NOTICE OF MEETING
HILLSIDE REVIEW BOARD
CITY OF ST. GEORGE
WASHINGTON COUNTY, UTAH

HILLSIDE REVIEW BOARD AGENDA REPORT: **07/15/2020**

The Cove

Case No. 2020-HS-007

SLOPE ANALYSIS
THE COVE
ST GEORGE, UTAH

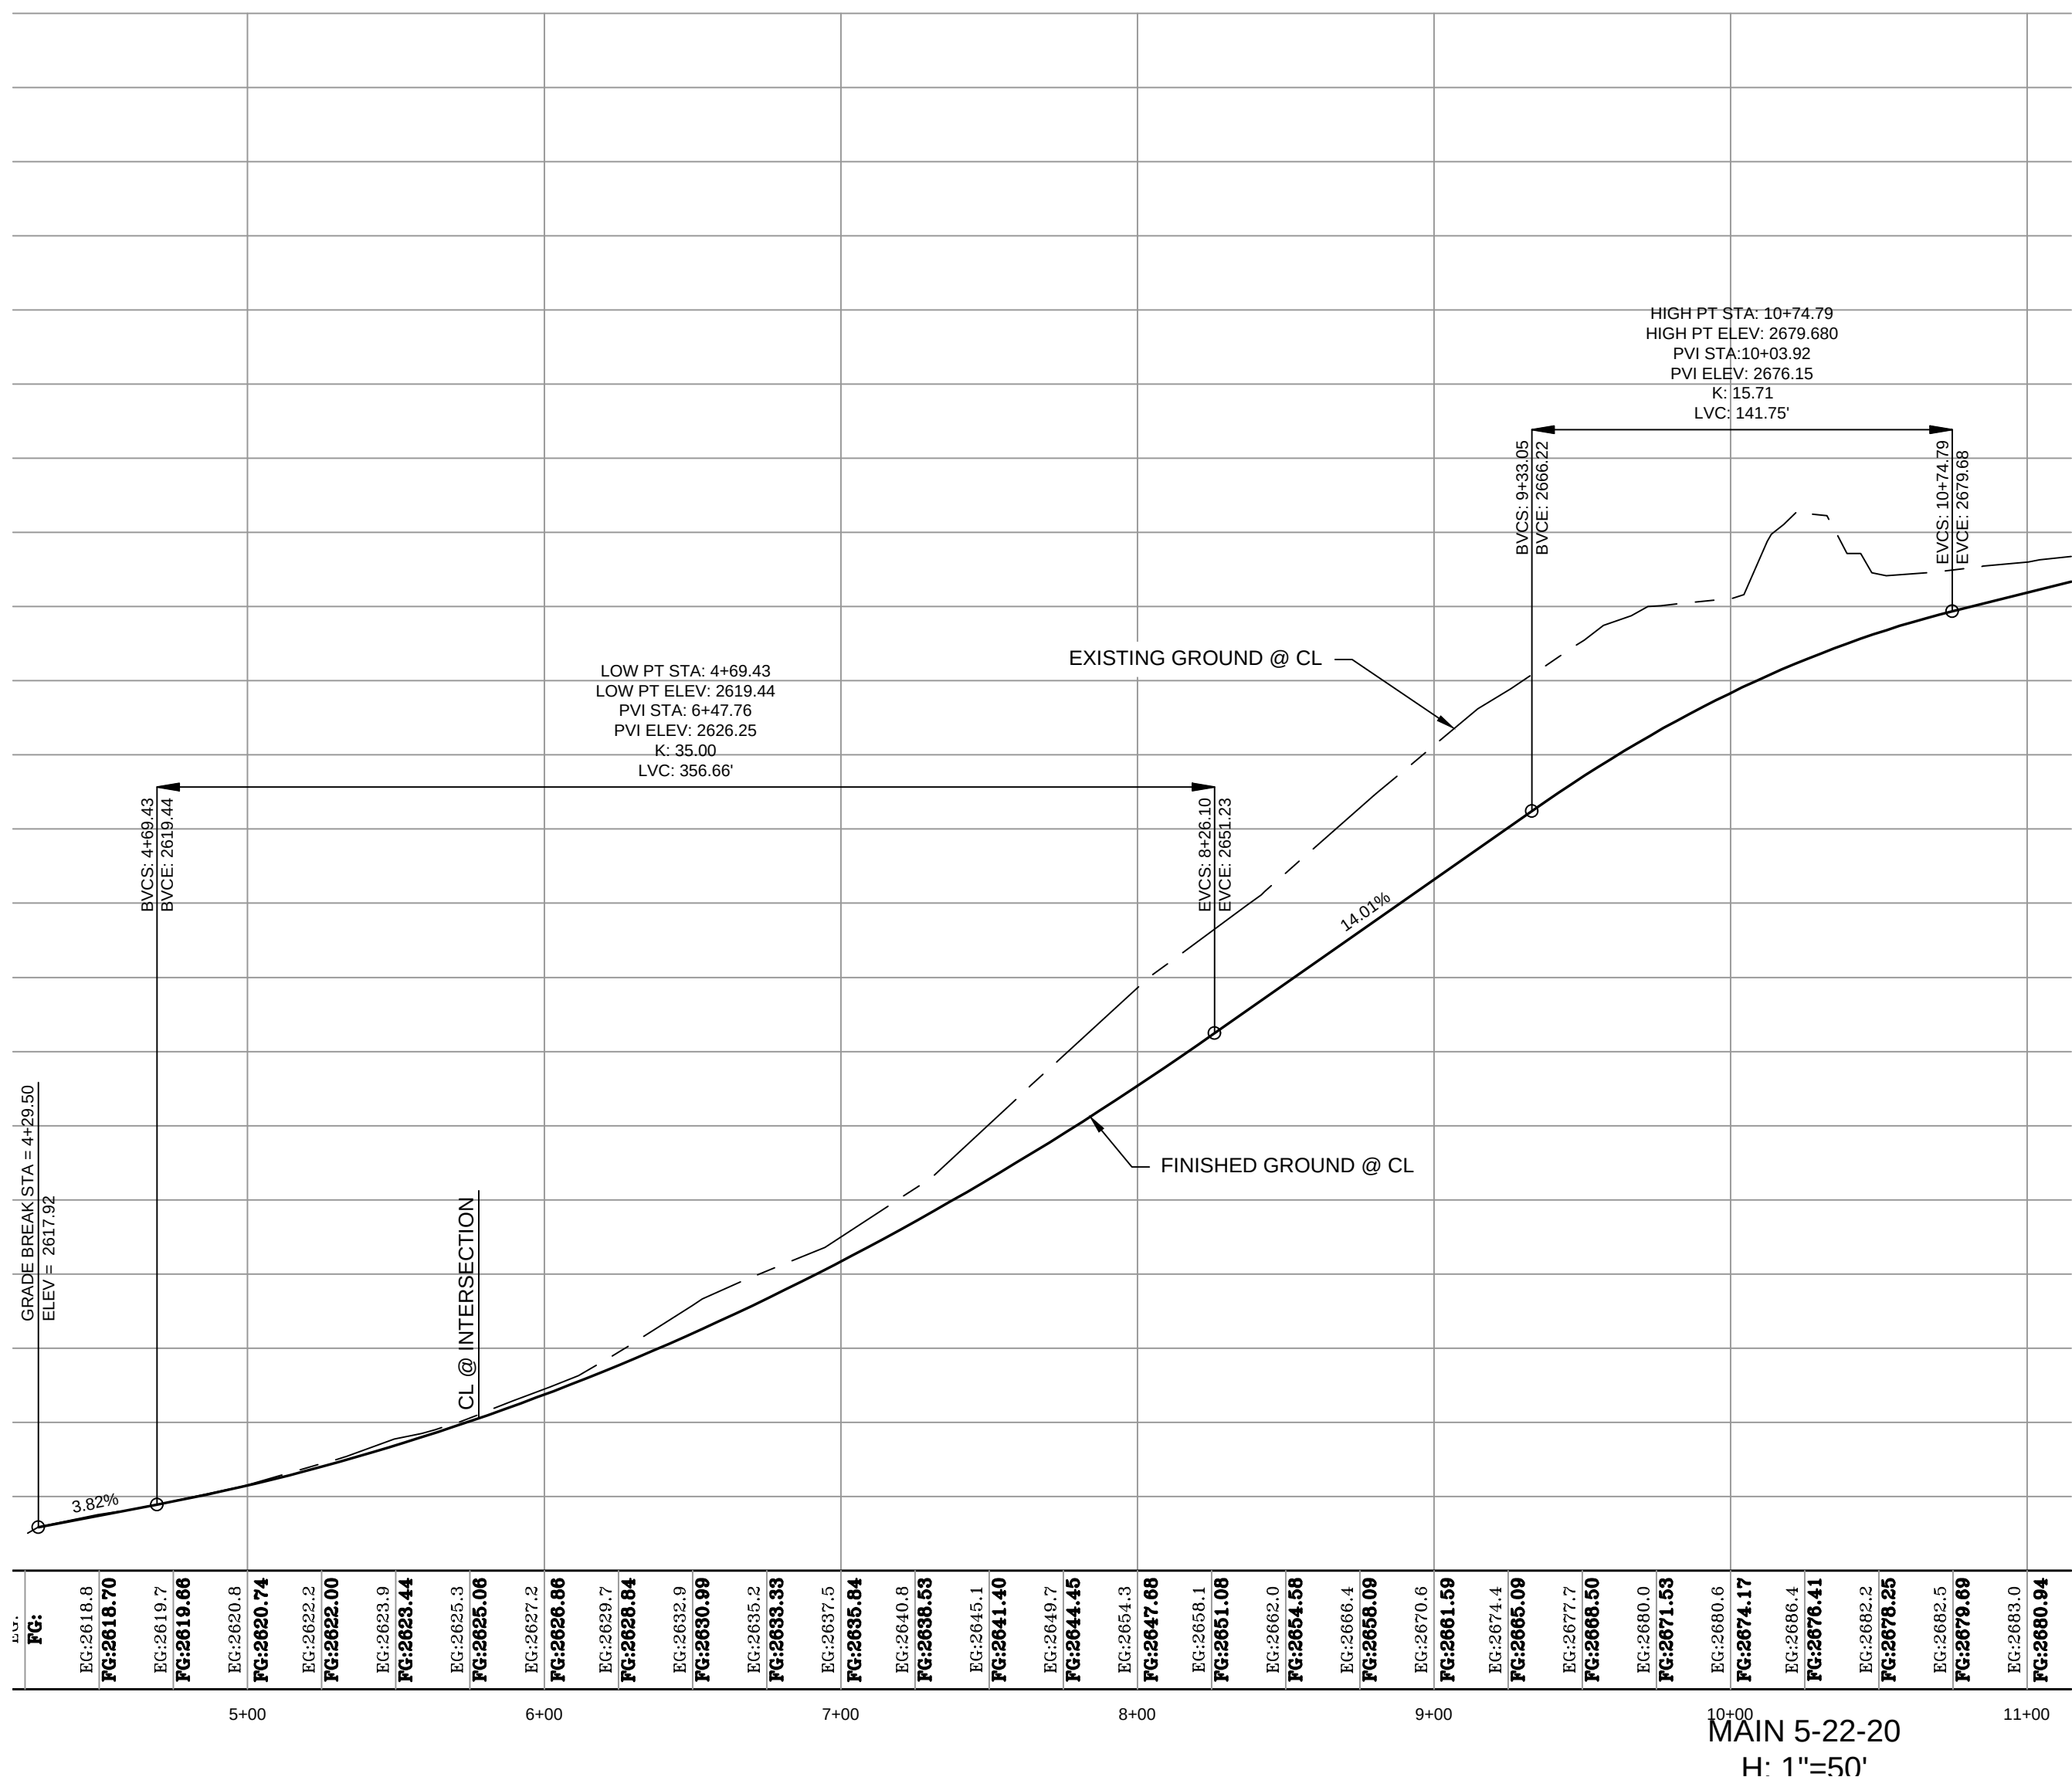
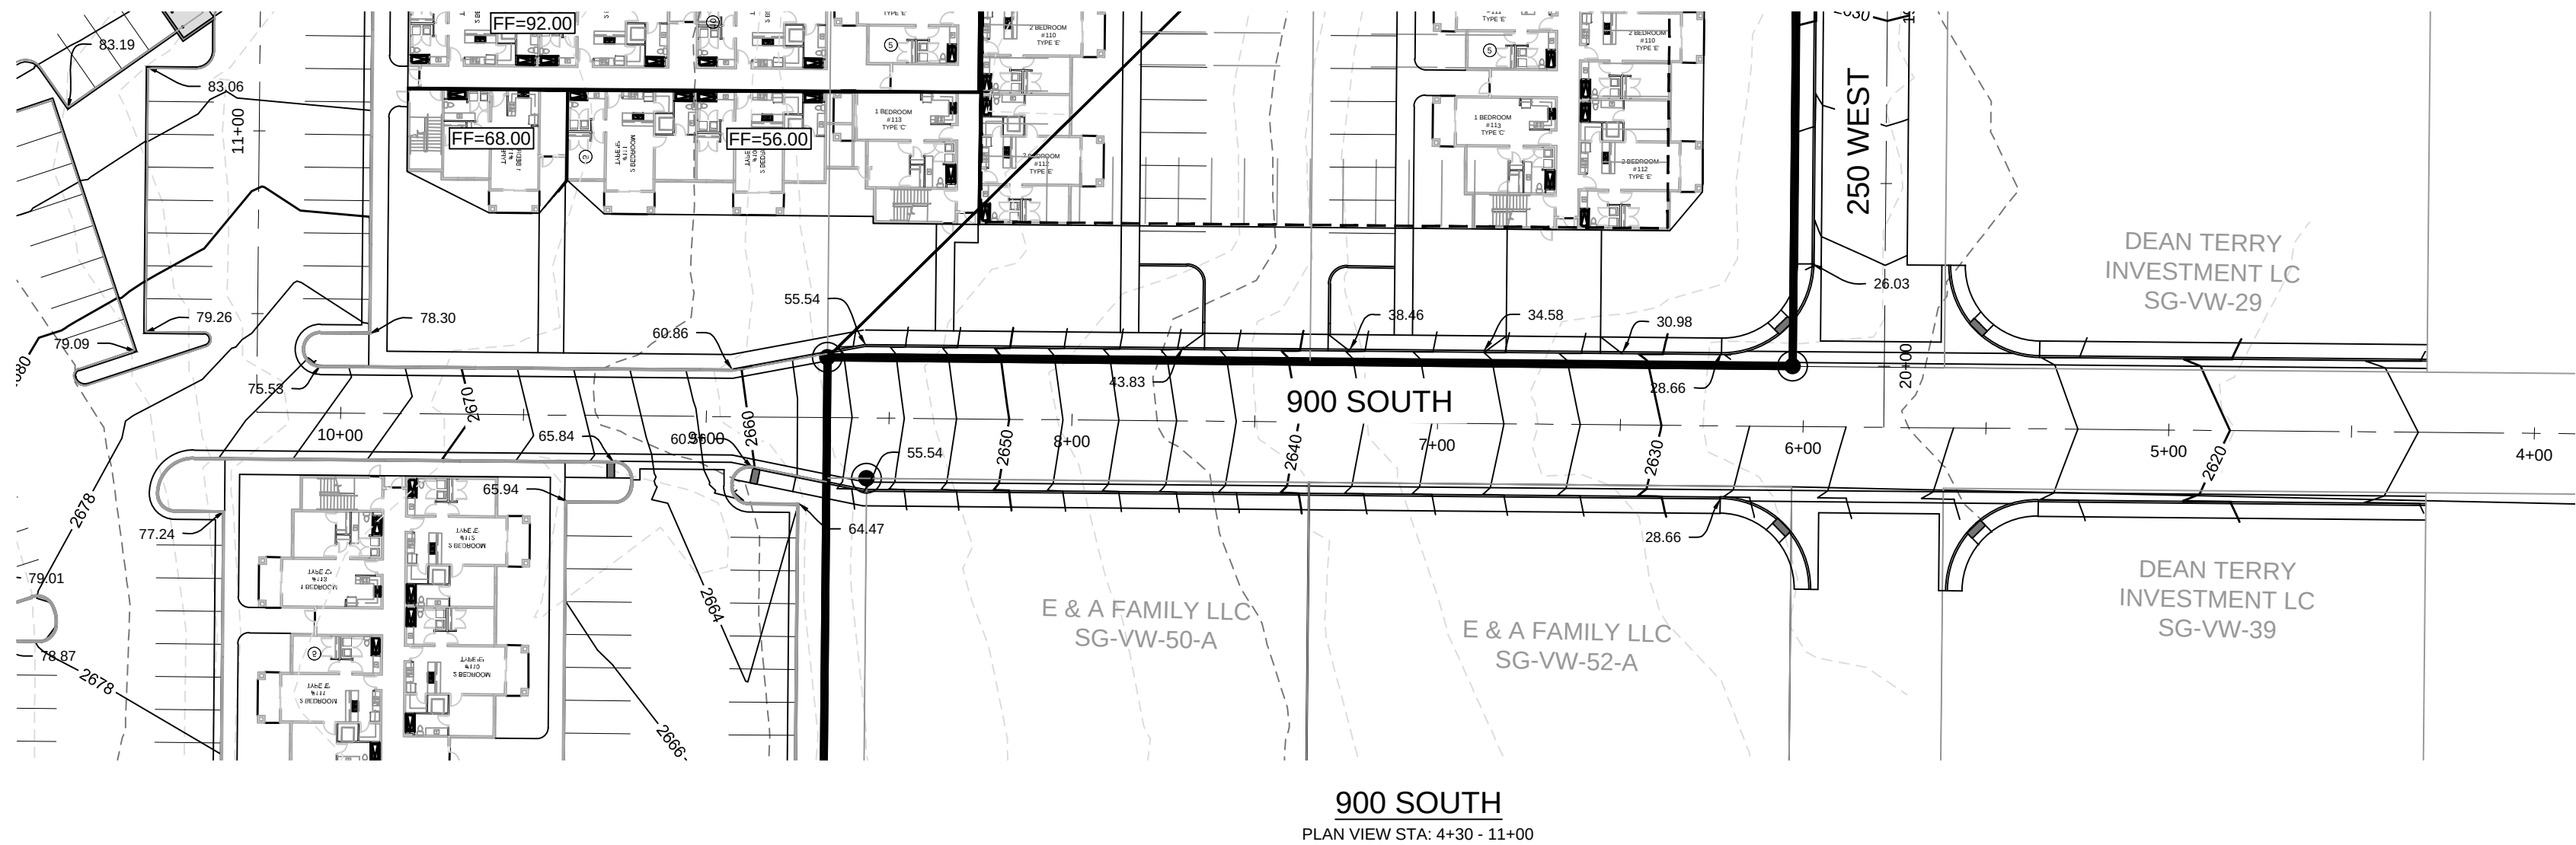
Wes Jenkins – I have a question for Brandee. On your slope analysis, you exceeded the 40%, right? On disturbance? I guess you just need to point that out to them. You're not following the ordinance so there will need to be a recommendation as to why you're doing that.

2192092	AGEC	Rockfall Hazard Area	Figure 2
---------	-------------	----------------------	----------

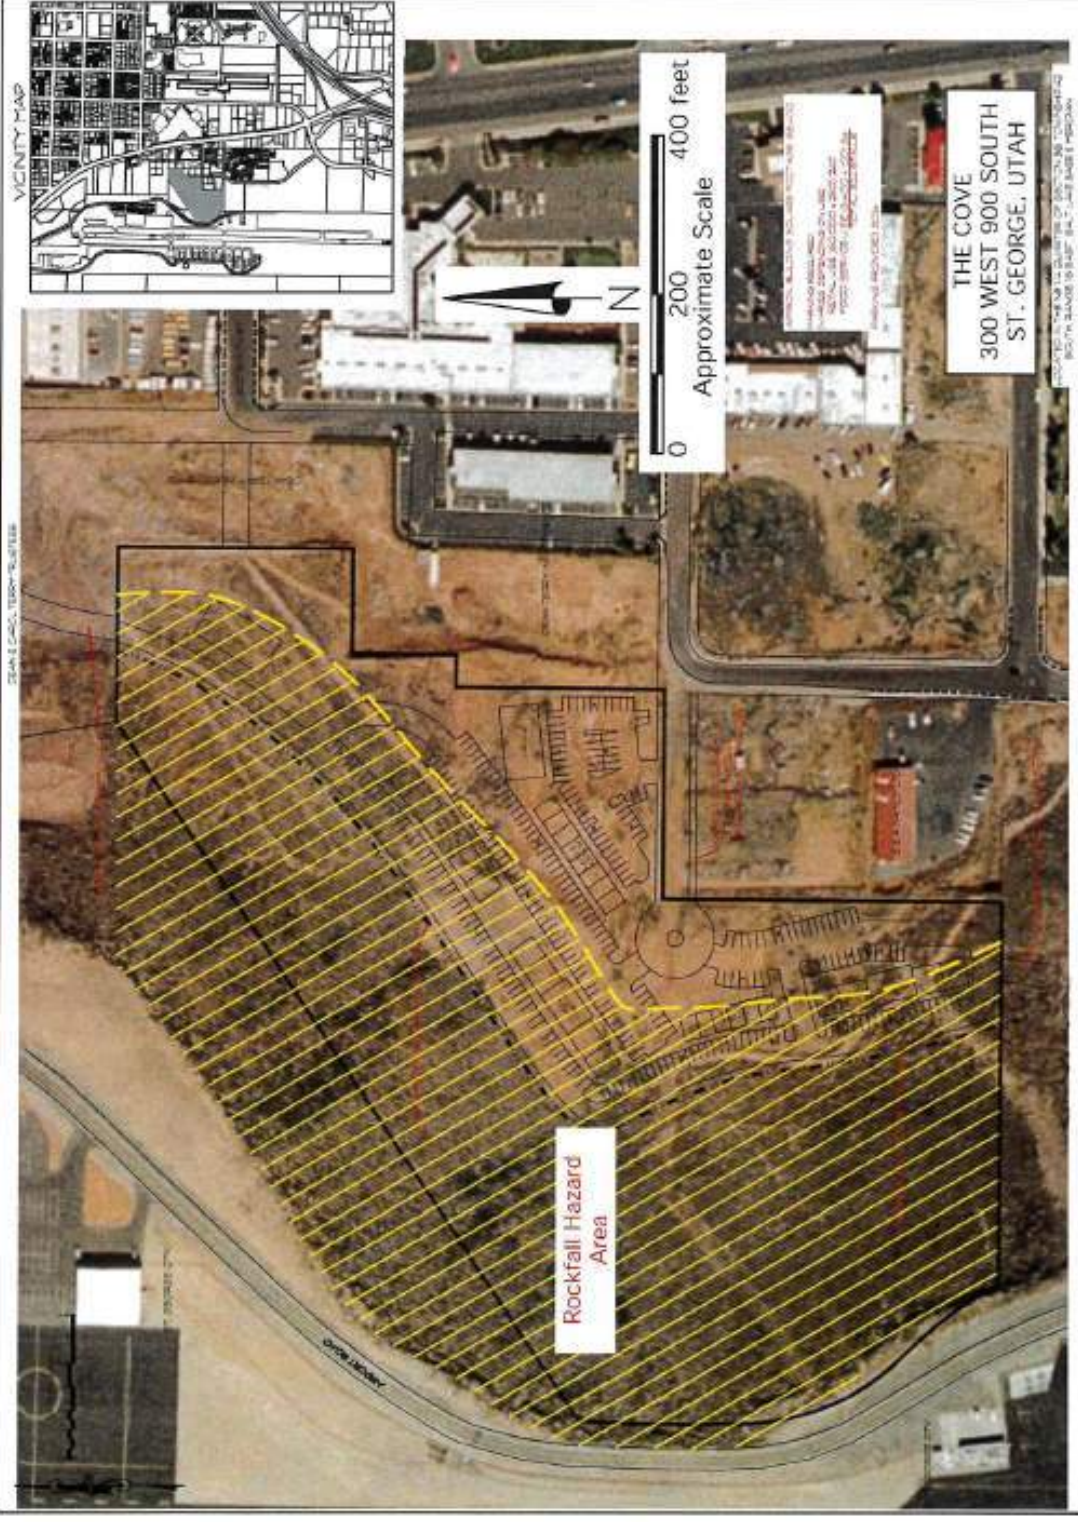
Wayne Roger – No, they don't, this one does go into the parking area. We will need to update our run out zone with the grading plan that we have now. That was done just for a natural slope, when you come and flatten that out it may shorten it a bit.

Wes Jenkins – You will have to provide that kind of detail so when you go to Planning Commission and Council you have to lay that out: this is the mitigation, the rock fall line is in the parking area but this is what we're going to do to mitigate it. We are outside of all the building areas. That needs to be included.
